ADDENDUM NO. 1

This addendum includes Item Number 1-1 thru 1-76. This addendum item shall be fully incorporated into the Bidding/Contract Documents and have the same force and effect as though originally included.

Life Sciences Collaboration
1910 N. Antelope Valley Parkway
Lincoln, Nebraska
TCEP No.: 716-002-12
Davis Design.: 12-0077
BVH No.: L12018.unl
November 27, 2013

Item 1-32: Sheet A1.01 – Lower Level Floor Plan & Reflected Ceiling Plan – Area A

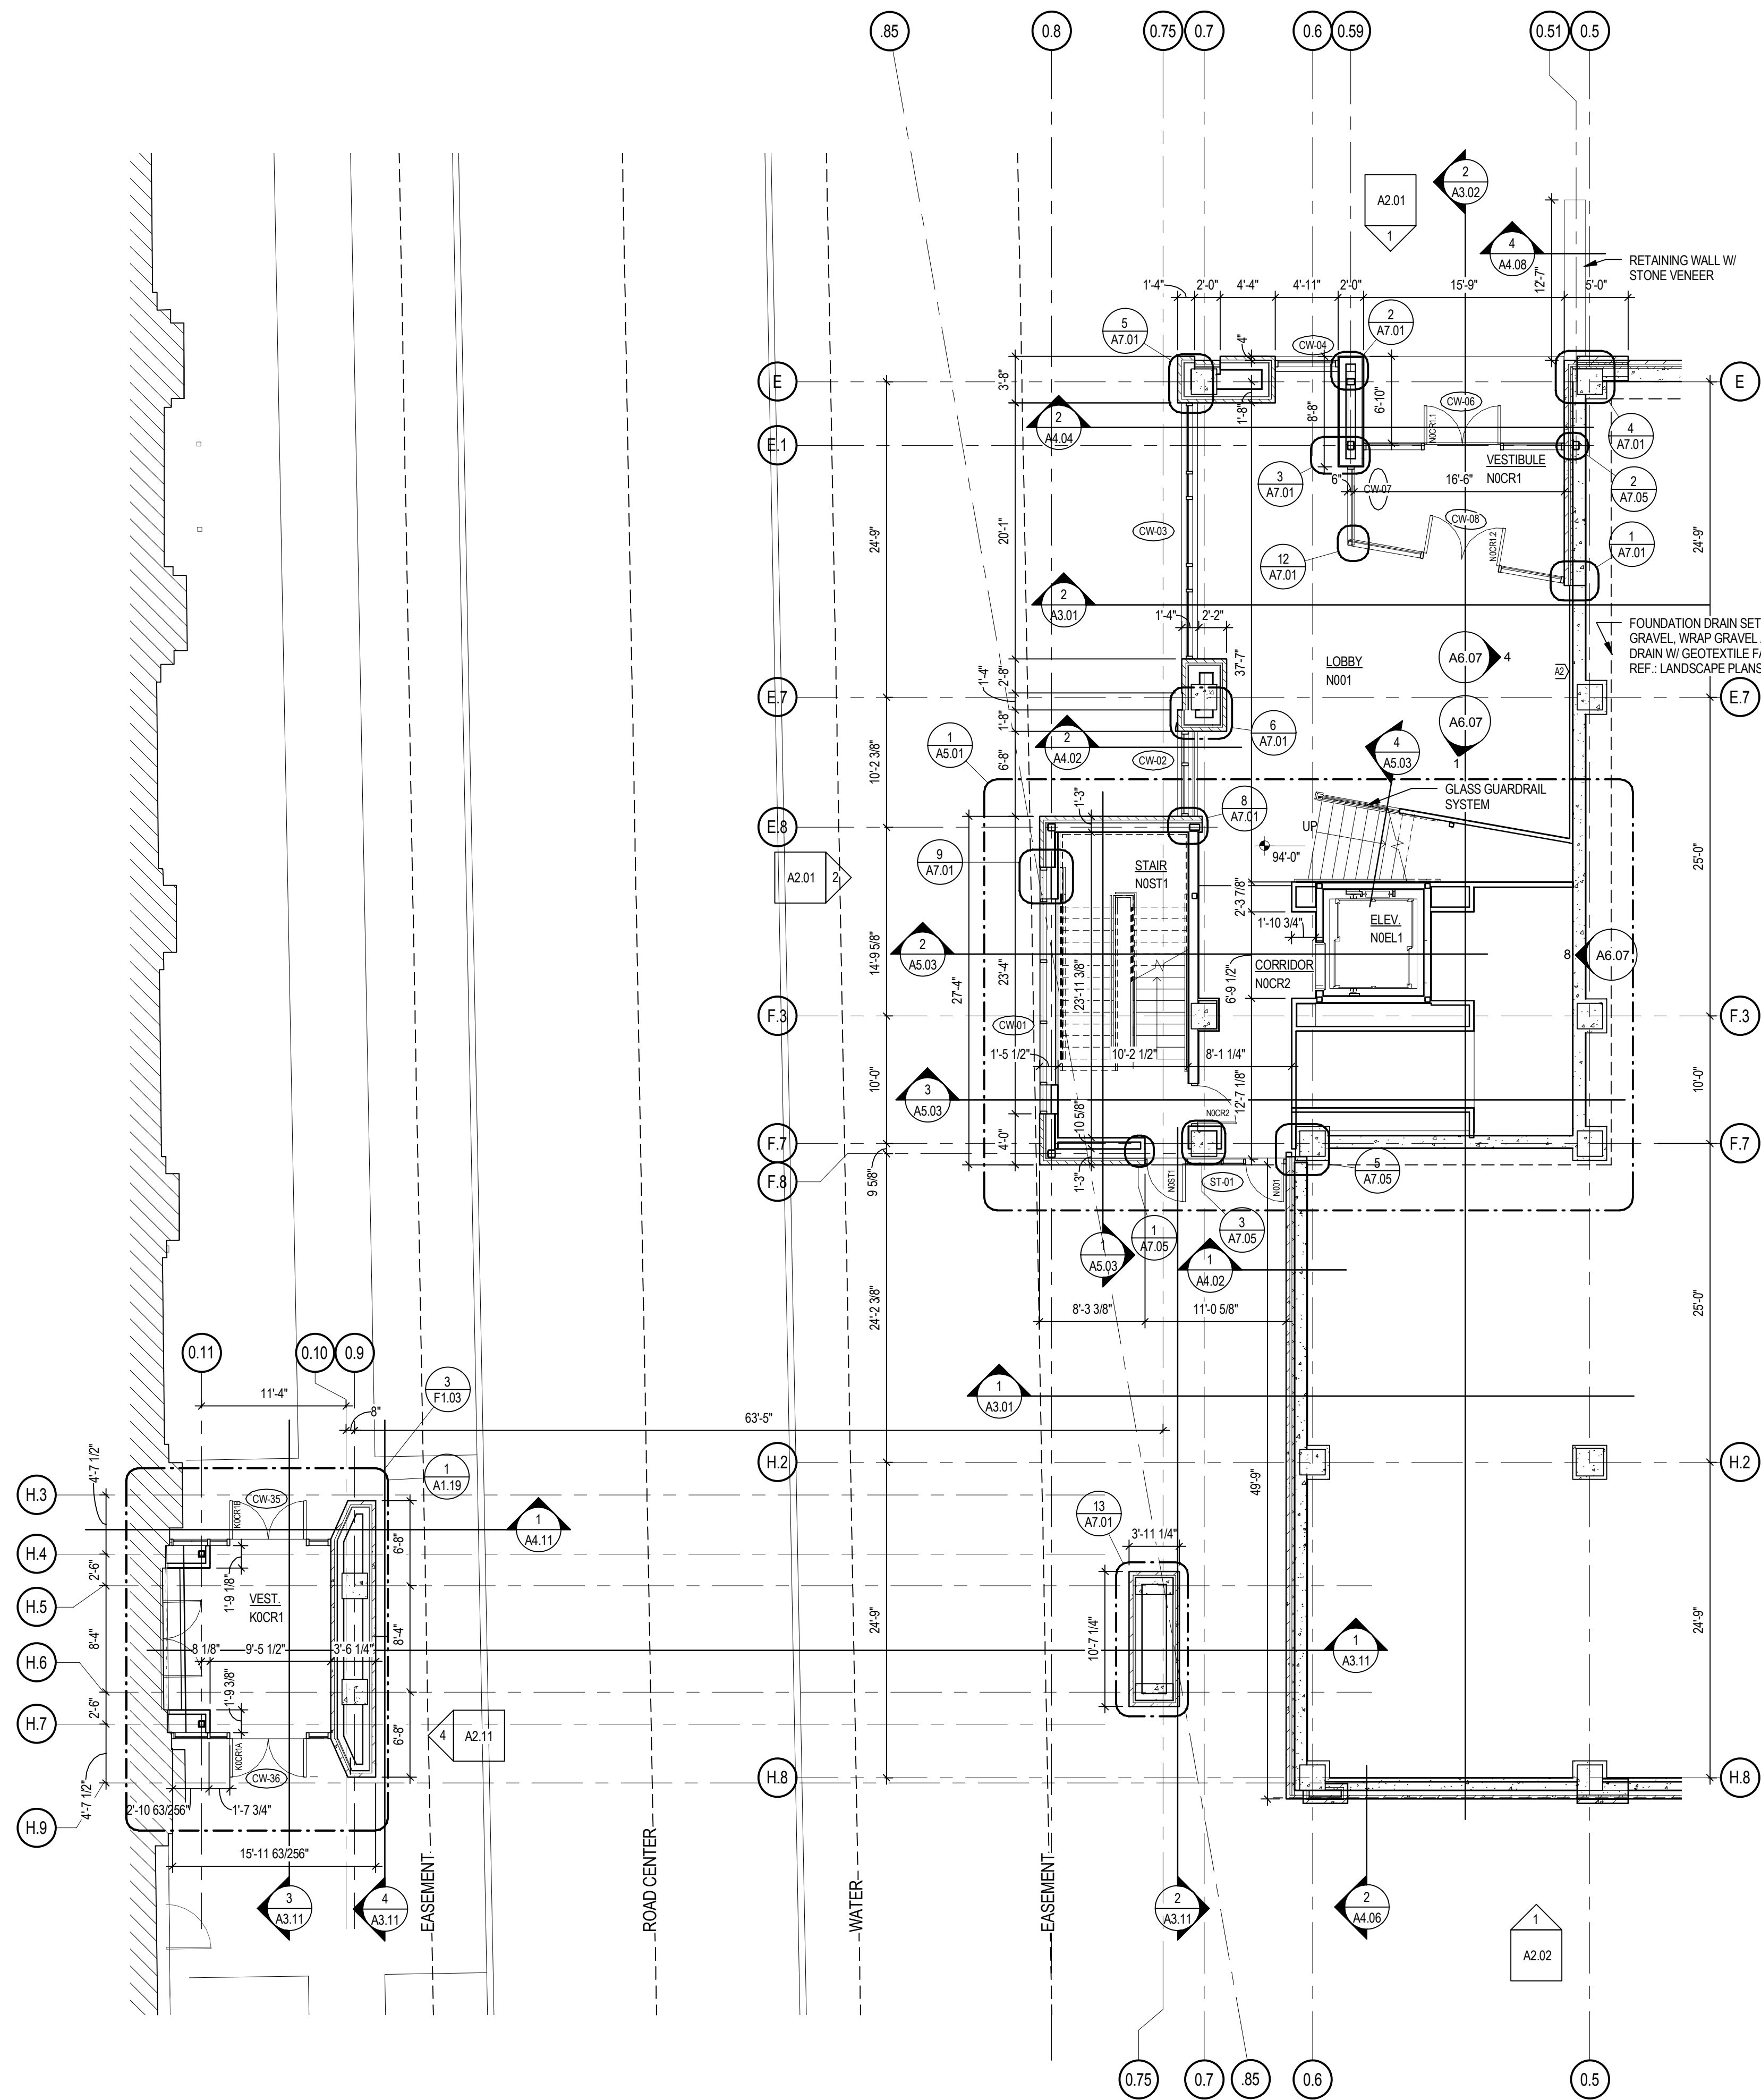
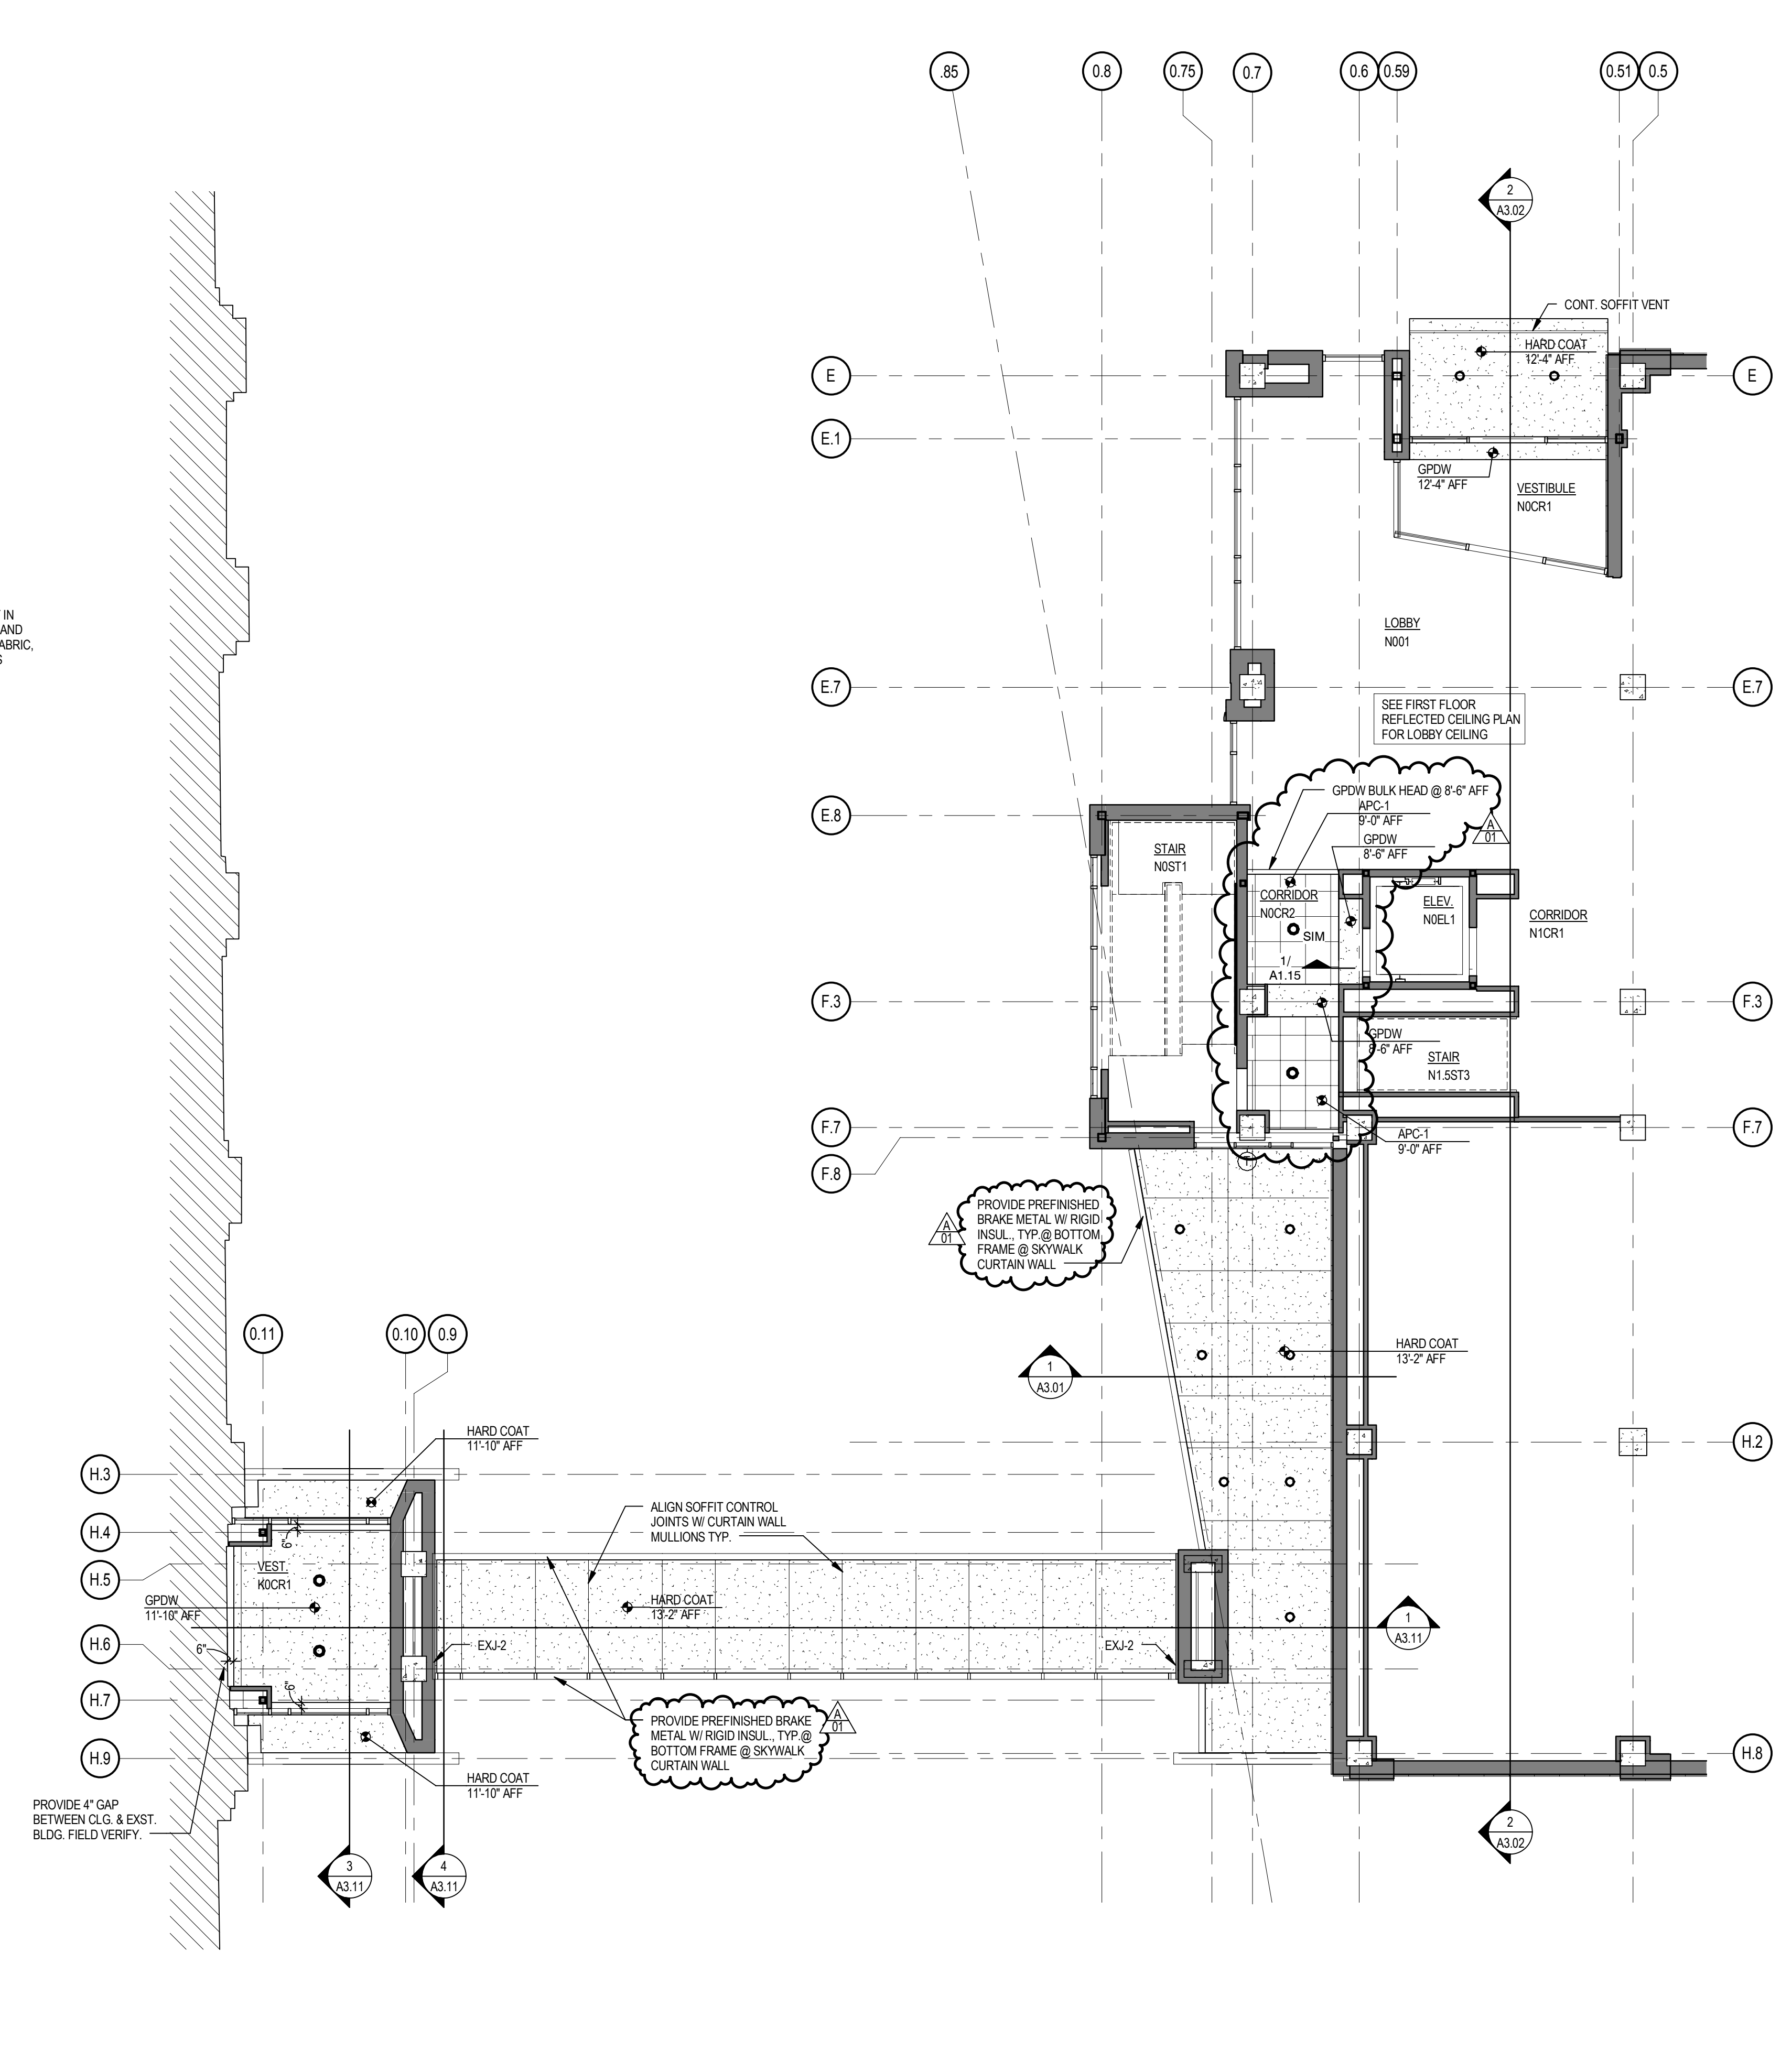
See revised sheet for updated ceiling at corridor N0CR2 and updated note at underside of Curtainwall at Skywalk Soffit.

Item 1-33: Sheet A1.19 – Skywalk Floor Plan & Reflected Ceiling Plan – Area A

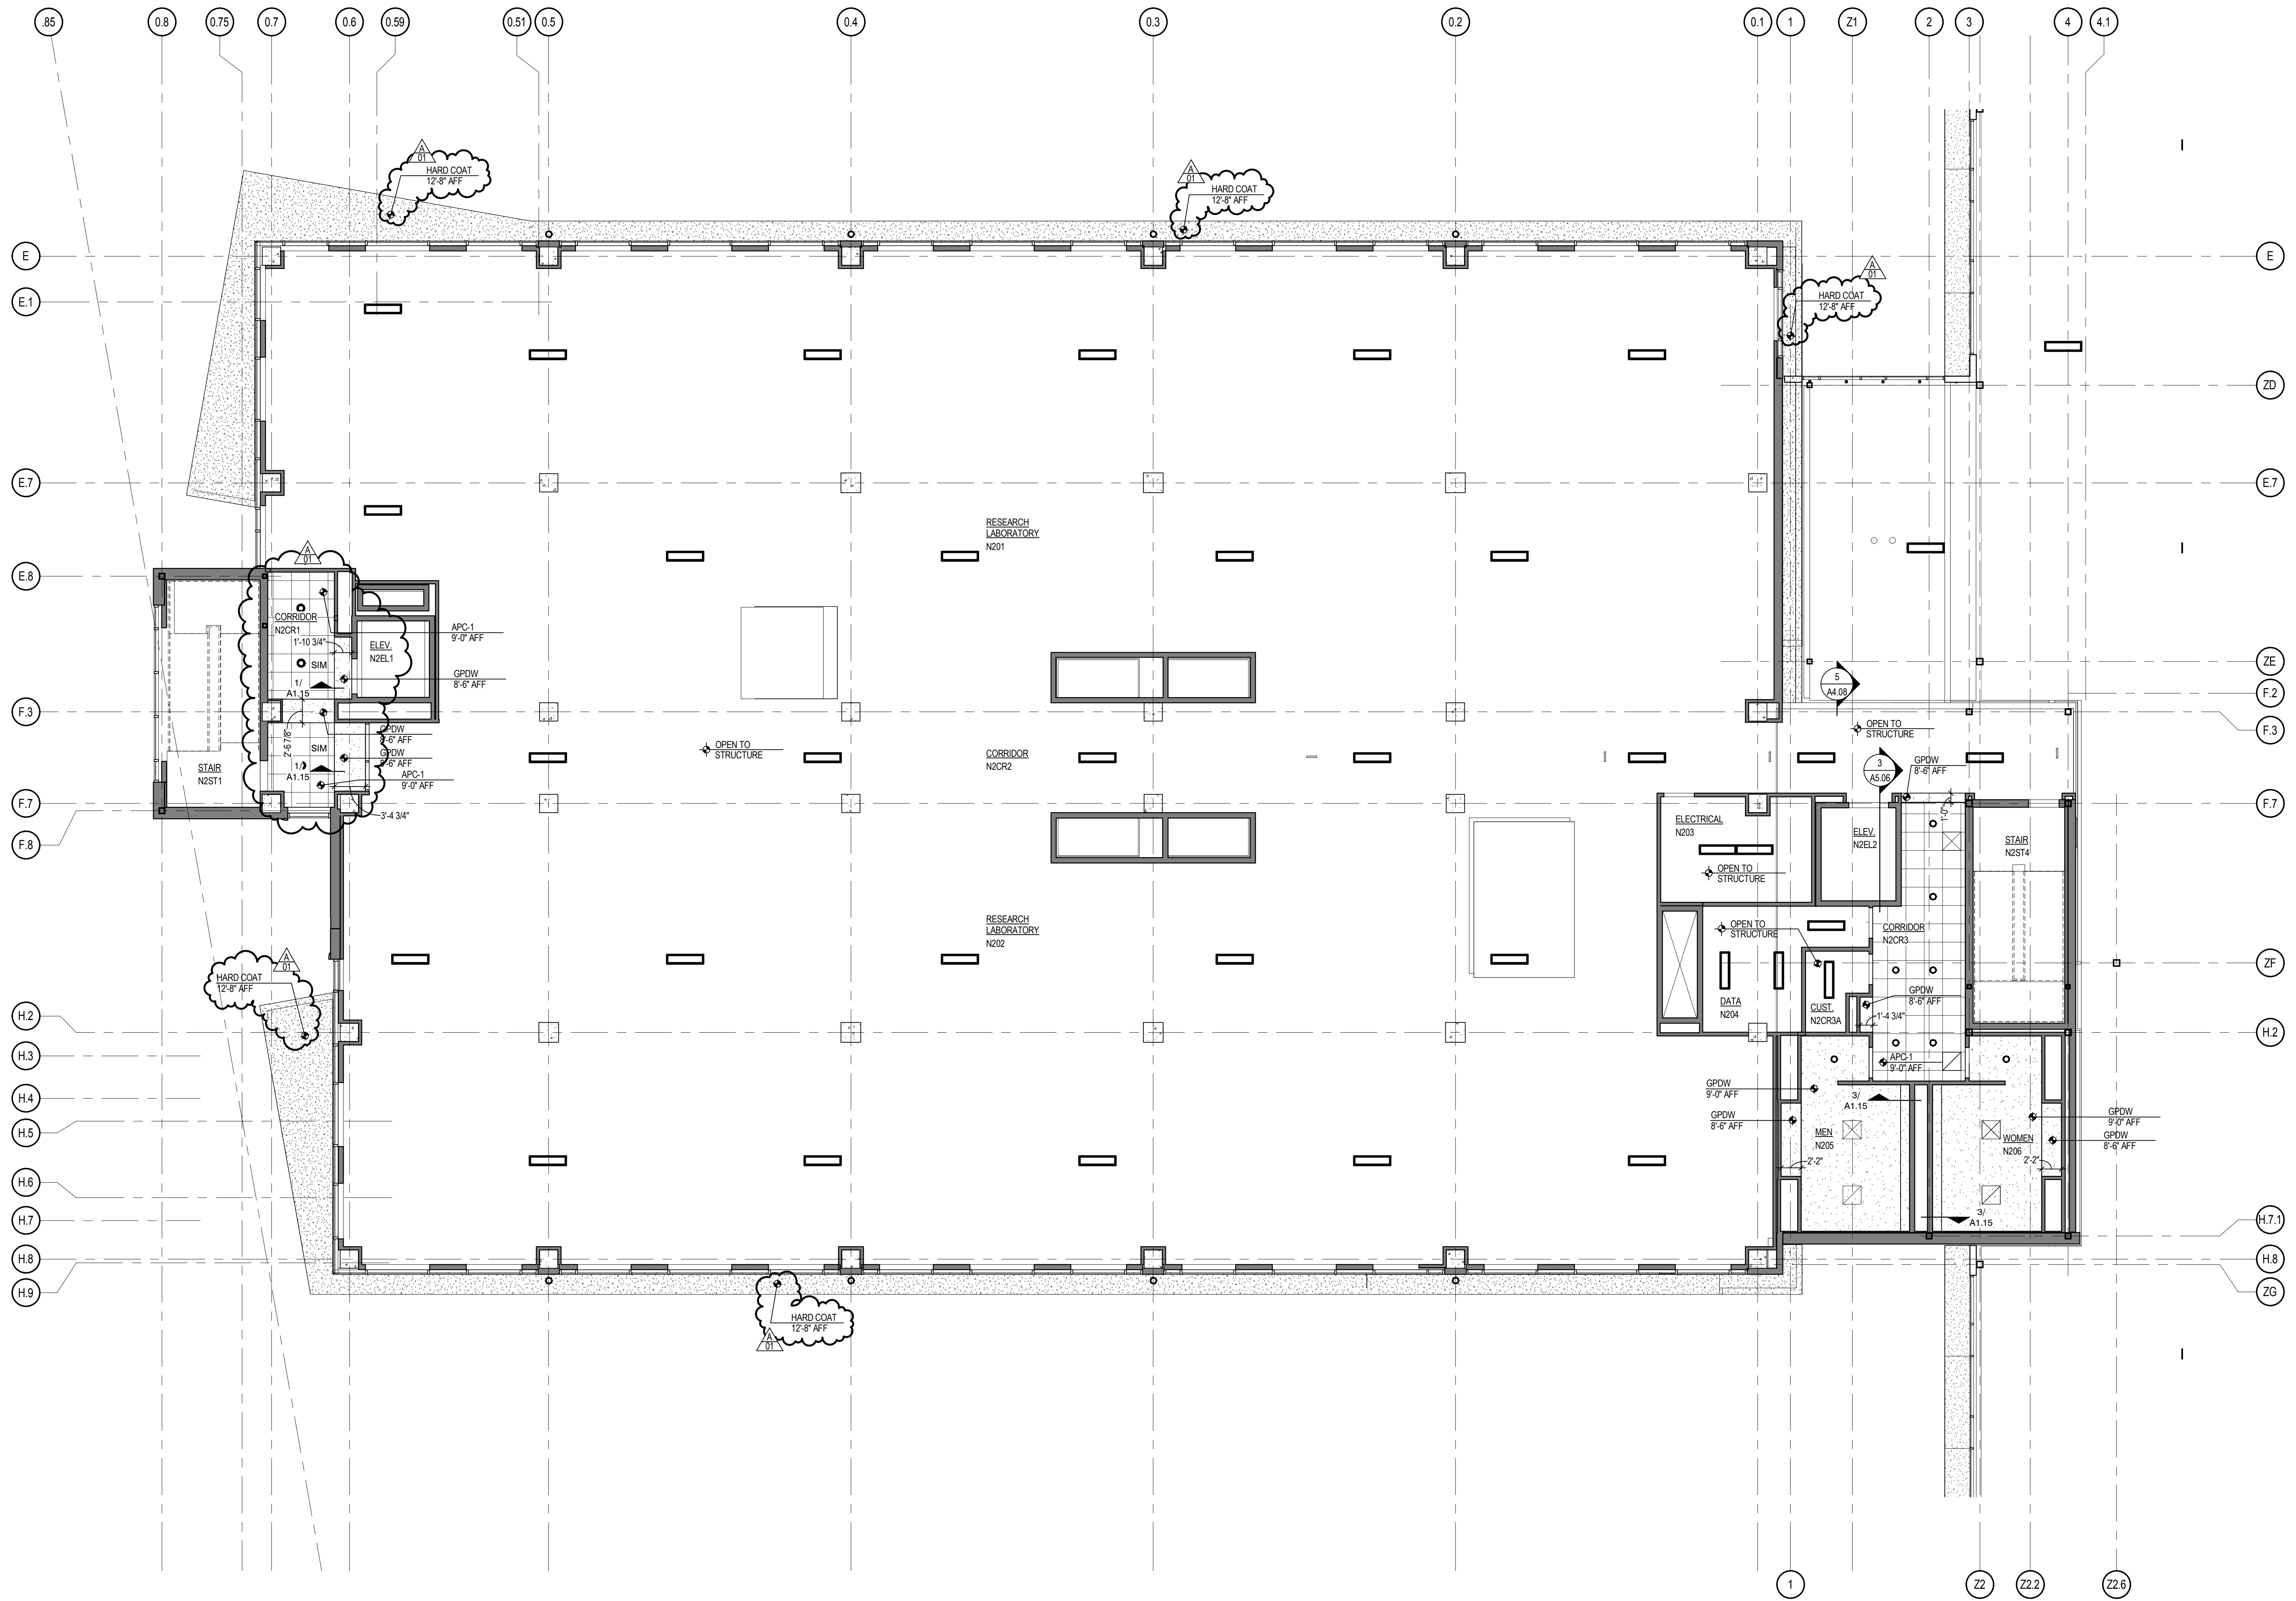
See revised sheet for updated Ceiling at skywalk and vestibule. See revised sheet for updated Curtainwall frame type reference tags and new detail reference tag.
